# HISTORIC AND DESIGN REVIEW COMMISSION

**HDRC CASE NO:** 2024-404  
**ADDRESS:** 362 E HUISACHE AVE  
**LEGAL DESCRIPTION:** NCB 3088 BLK 4 LOT 15  
**ZONING:** R-4, H  
**CITY COUNCIL DIST.:** 1  
**DISTRICT:** Monte Vista Historic District  
**APPLICANT:** Anthony Chen/Aeonium Investments LLC  
**OWNER:** BEAM GREGORY & ALISON  
**TYPE OF WORK:** Conceptual review for rear detached garage construction  
**APPLICATION RECEIVED:** November 25, 2024  
**60-DAY REVIEW:** January 24, 2025  
**CASE MANAGER:** Bryan Morales  
**REQUEST:**

The applicant is requesting conceptual approval to construct an approximately 360 sf detached rear accessory structure.

**SITE PLAN**  
SCALE: 3/32" = 1'

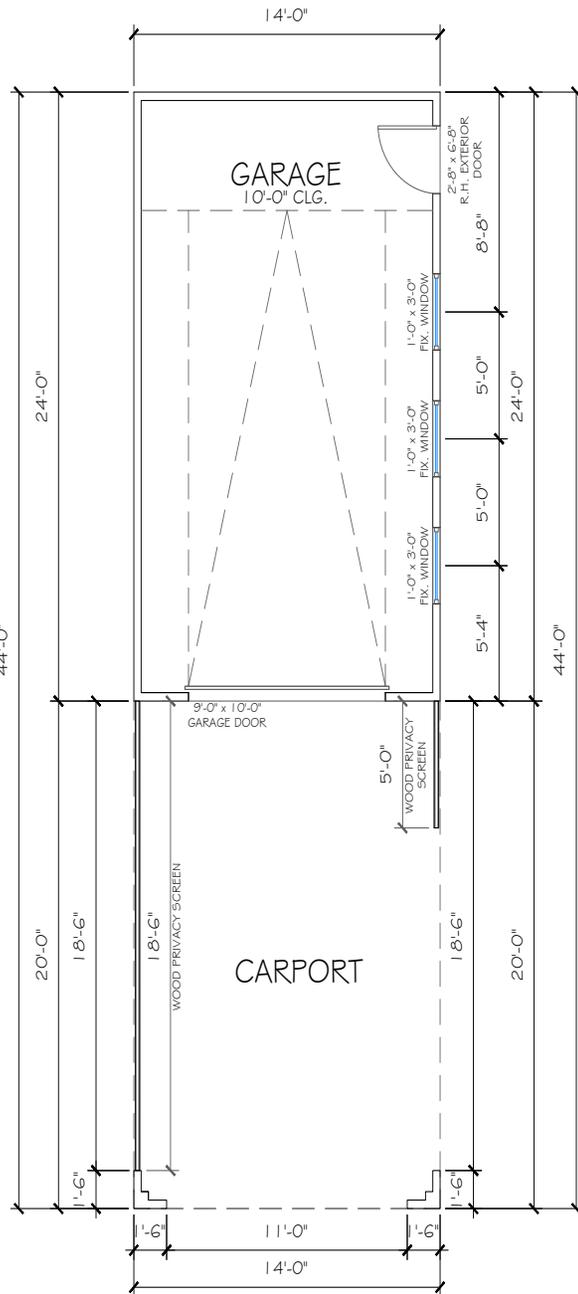
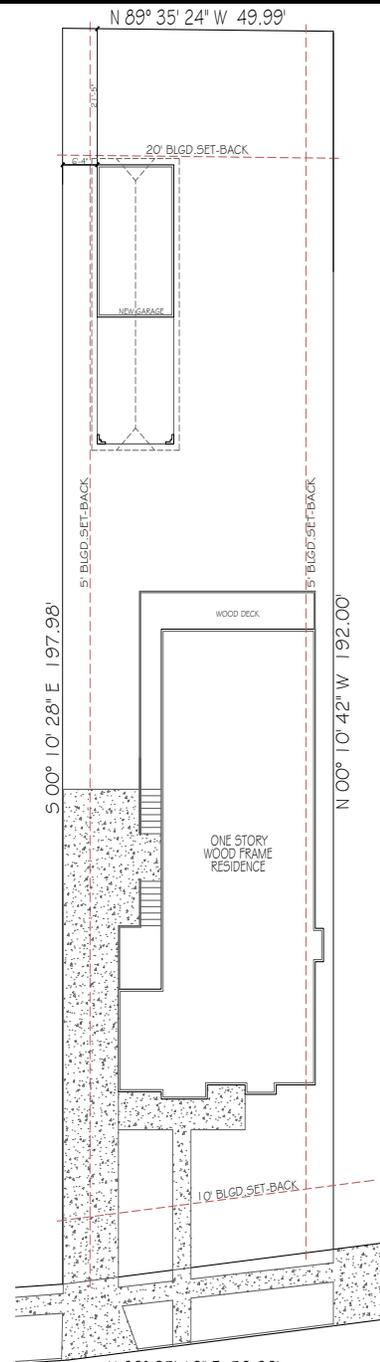
- c. ORIENTATION & SETBACKS – The applicant has proposed both an orientation and setback for the new accessory structure that are consistent with the Guidelines for New Construction 5.B.

**FRONT ELEVATION**  
SCALE: 1/4" = 1'

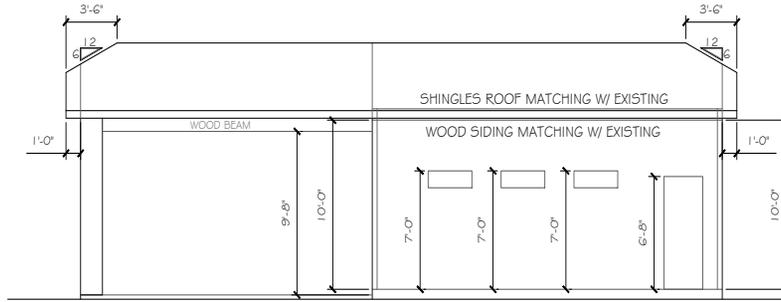
- f. ARCHITECTURAL DETAILS (FENESTRATION PATTERN) – The applicant is proposing to install one Craftsman wood door on the right façade, one garage door on the front façade, and three clerestory windows on the right façade. The Guidelines for New Construction 2.C.i. related to window and door openings stipulates to incorporate window and door openings with a similar proportion of wall to window space as typical with nearby historic facades. Staff finds the proposed fenestration pattern generally appropriate; however, the applicant should incorporate single-sashed windows on the right façade rather than the requested clerestory windows.

- ii. That the applicant install a fully wood garage door or a garage door with a design that mimics wood construction and features a smooth finish without a faux wood grain texture. Final garage door specifications must be submitted to staff for review and approval prior to the issuance of a Certificate of Appropriateness.
- iii. That the applicant meets all setback standards as required by city zoning and obtain a variance from the Board of Adjustment if applicable.

**RIGHT ELEVATION**  
SCALE: 1/4" = 1'

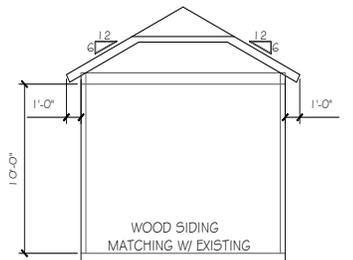
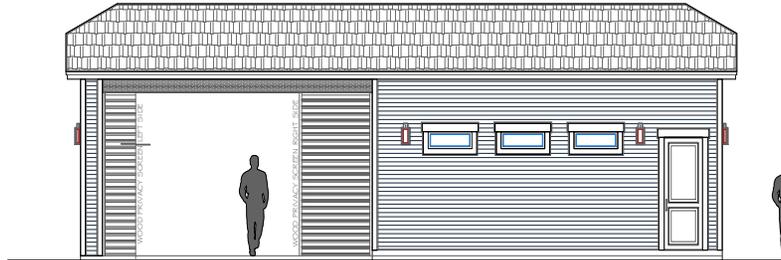
- g. WINDOWS (MATERIALS) – The applicant has not provided material information on the proposed windows on the right façade. Per *Standard Specifications for Windows in New Construction*, new windows on new construction should relate to the windows of the primary historic structure in terms of materiality and overall appearance. Windows used in new construction should be similar in appearance to those commonly found within the district in terms of size, profile, and configuration. Staff recommends that the applicant install wood or aluminum-clad wood windows on the rear accessory structure. An alternative window material may be proposed, provided that the window features meeting rails that are no taller than 1.25" and stiles no wider than 2.25".

- i. That the applicant installs a fully wood or aluminum-clad wood window that meet staff's standard window stipulations and submits updated specifications to staff for review and approval. The windows should feature an inset of two (2) inches within facades and should feature profiles that are found historically within the
